SERVICE BULLETIN

REPLACEMENT OF FUEL PRESSURE REGULATOR ASSY. PART NO. 887130 FOR ROTAX® ENGINE TYPE 914 (SERIES) SB-914-040

Replacement of fuel pressure regulator assy. part no. 887130 for ROTAX® engine type 914 (Series).

Fig. 1

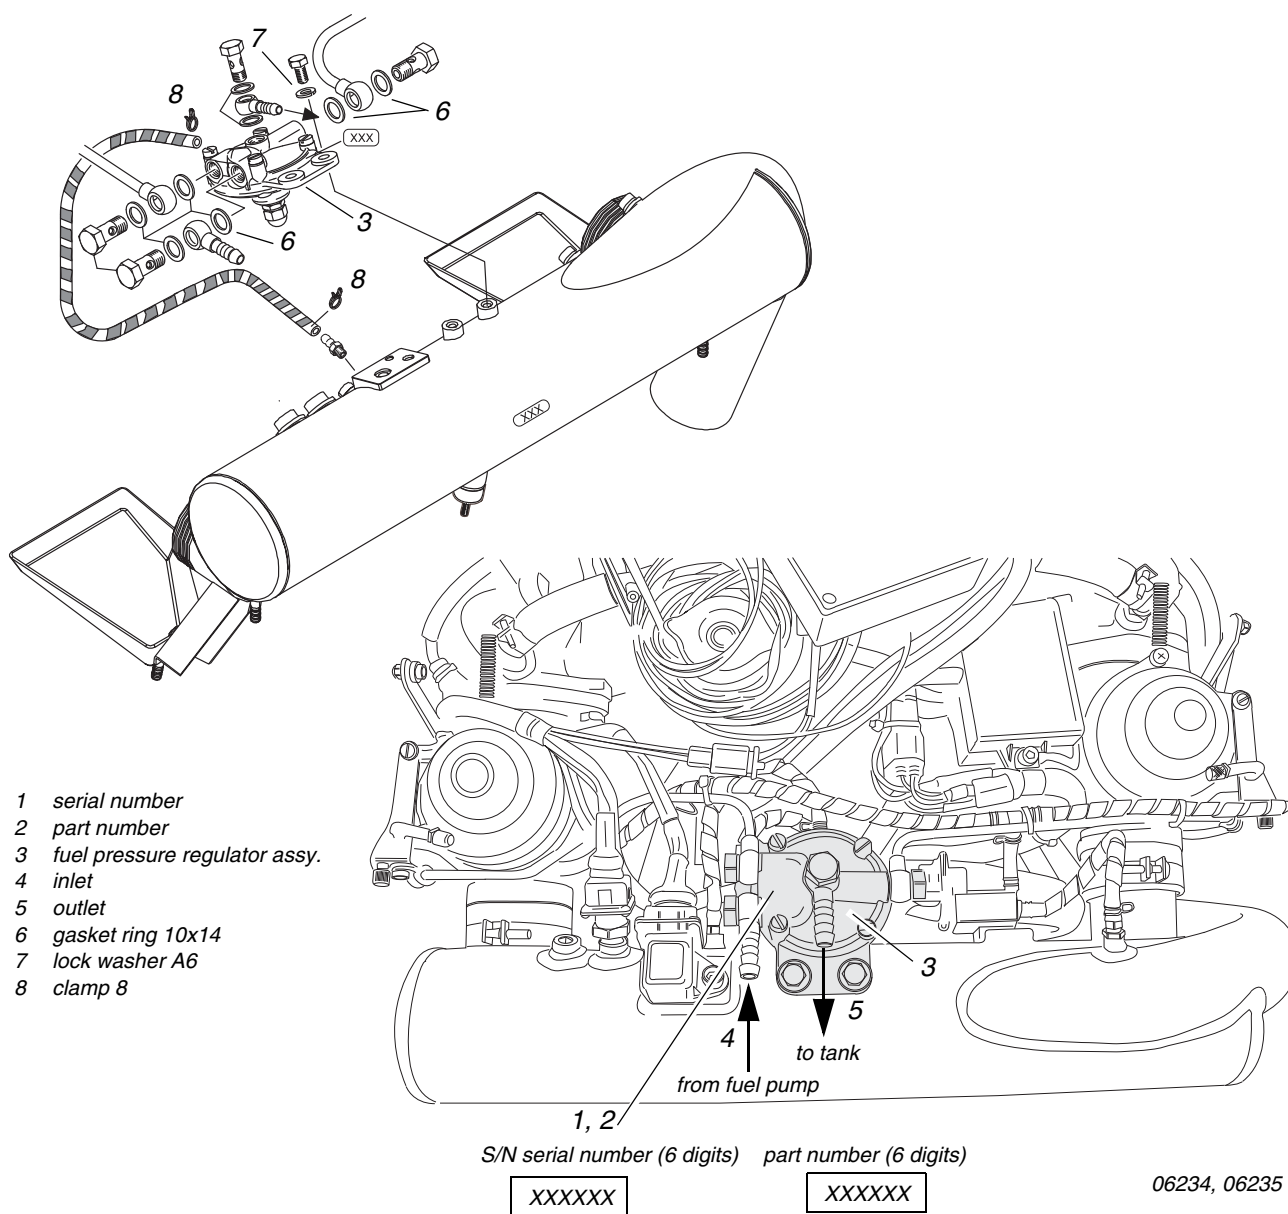
- ◆ **NOTE:** The corresponding serial number (1) and part number (2) is visible on the flange of the fuel pressure regulator assy. (3) (see fig. 1).

Isolated manufacturing deviations at the threads of the fuel pressure regulator could result in slightly leaks in the area of the banjo bolt for the fuel return to tank.

1. Visual check of the pressure regulator assy. (3).
2. Fuel pressure regulator assy. disassembly in accordance with the relevant Maintenance Manual.
3. Fuel pressure regulator assy. assembly in accordance with the relevant Maintenance Manual.

1. Check the correct fuel pressure (approx. 250 hPa above the airbox pressure). If necessary, adjust the fuel pressure in accordance with the relevant Maintenance Manual.
